Subject: Duane Arnold Energy Center
Docket No: 50-331
Op. License No: DPR-49
Relief Requests NDE-028, Revision 1 and MC-R008;
RRF-F002 Flaw Evaluation

RELIEF REQUEST NUMBER: MC-R008

RELIEF REQUEST NUMBER: NDE-R028, REVISION 1

**Attachment 2 to NG-00-0111
Flaw Evaluation for RRF-F002**

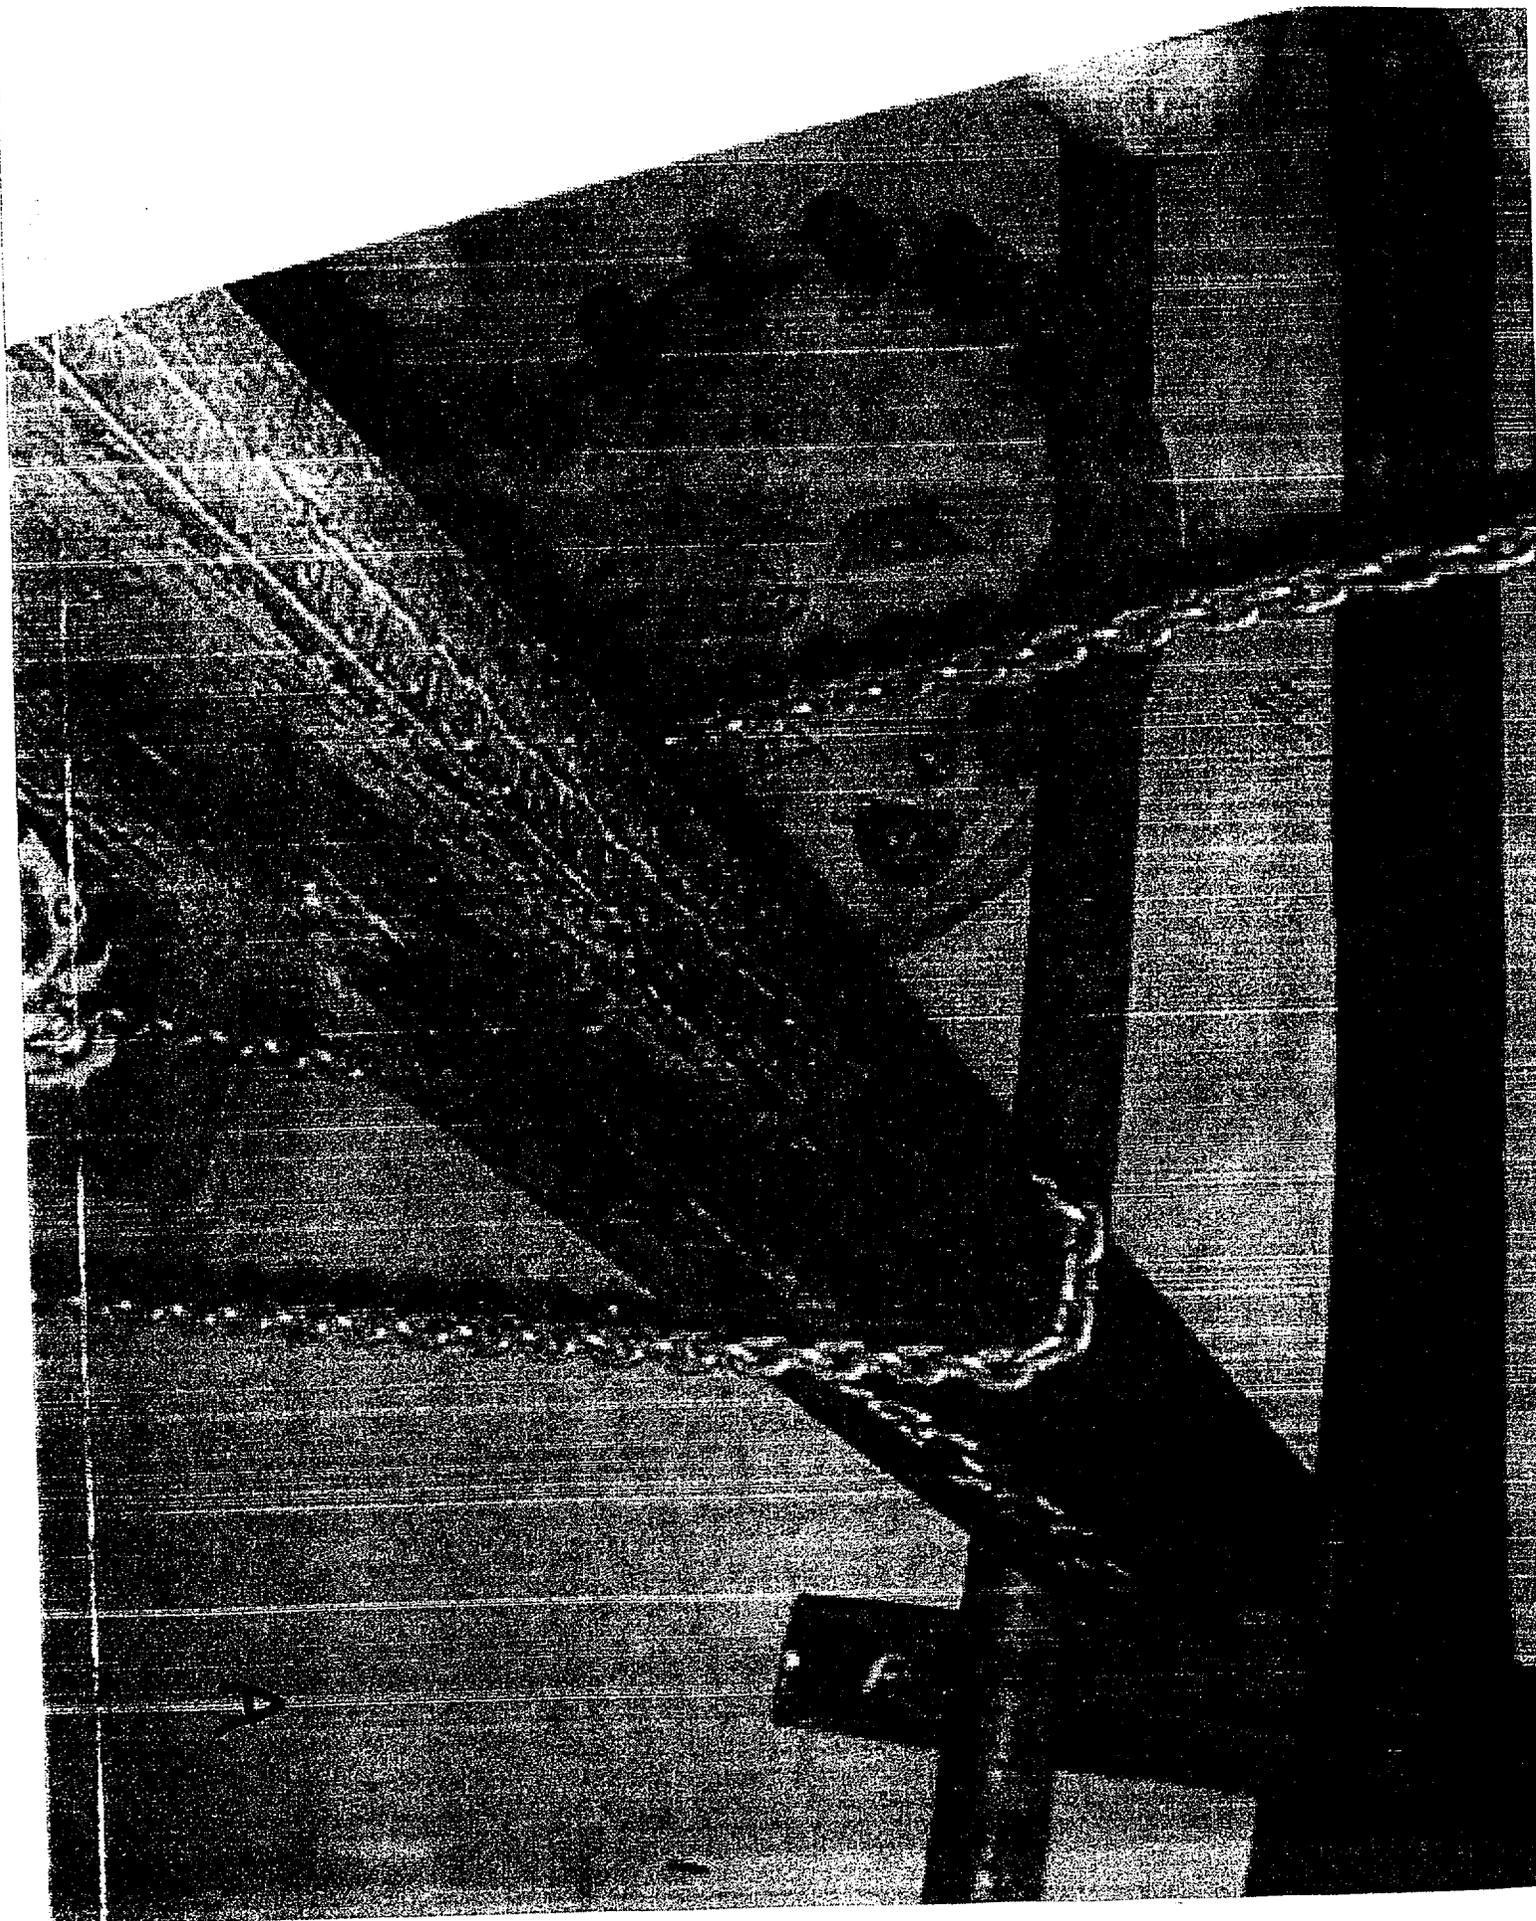
During RFO 16, the Drywell Stabilizer X-58A with the associated bolting was scheduled for examination. It was discovered that the well water piping associated with the 7A cooler prohibited the removal of the bolting. Without removal of the bolting, the integral attachment and the associated reinforcing structure cannot be examined. (See attached photos). In order to perform the VT-3 visual examination, the well water piping would need to be cut and re-welded into place. This would require draining of the well water system, hot work permit, welding, and additional personnel exposure to complete the work. Based on dose measurements obtained during work activities during RFO 16, dose rate in the general area is about 28 to 50 mr per hour. Allowing 8 person-hours to perform the aforementioned activities, the total dose would be approximately 300 millirem. Examination of the Drywell Stabilizer X-58A, which includes the reinforcing structure and the integral attachment to the outside diameter (OD) of the Drywell, has only a small potential of increasing plant safety margins and a very disproportionate impact on expenditures of plant manpower and radiation exposure.

Pursuant to 10CFR 50.55a(a)(3)(ii), the DAEC requests relief from the VT-3 visual examinations of the reinforcing structure and integral attachment of the Drywell Stabilizer X-58A. Once per period, the General Visual Examination of the accessible surfaces will be performed. Once per interval, the associated bolting will be examined in-place under tension as allowed by Relief Request MC-R003.

Figure 1. Flaw in Recirculation Inlet Nozzle N2F

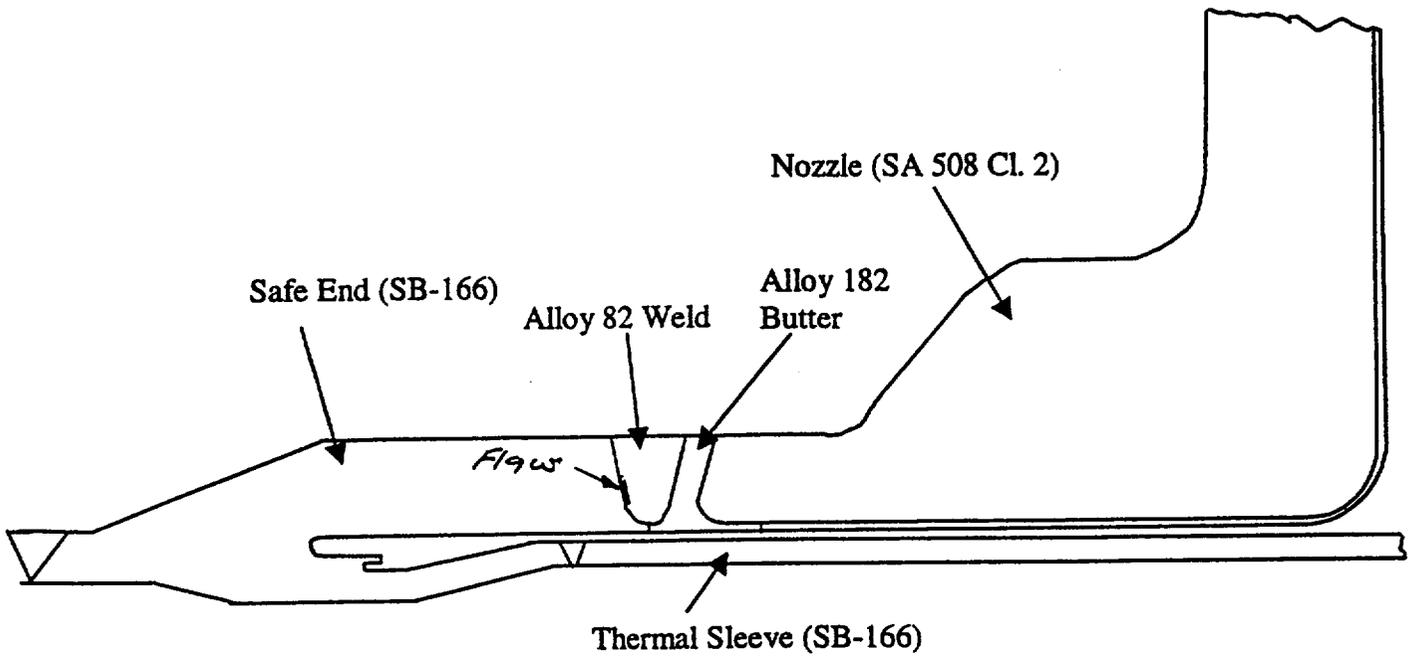
This calculation documents the results of a fracture mechanics evaluation of a subsurface flaw in the safe end-to-nozzle weld of Recirculation Inlet Nozzle N2F (Figure 1). The flaw has a depth of 0.30 in and a length of 0.50 in. The flaw is located at the weld-base metal interface between the Alloy 82 weld and the Alloy 600 safe end. The flaw has been interpreted as a lack of fusion during safe end replacement in 1978 and is not considered to be a service-induced flaw.

The flaw in Recirculation Nozzle N2F was evaluated in accordance with the flaw evaluation procedures of IWB-3641 of ASME Section XI (1989 Ed.). The allowable flaw depth was determined to be 0.720 in, which is greater than the actual flaw depth of 0.300 in. Therefore, it is acceptable to leave the flaw in the nozzle.
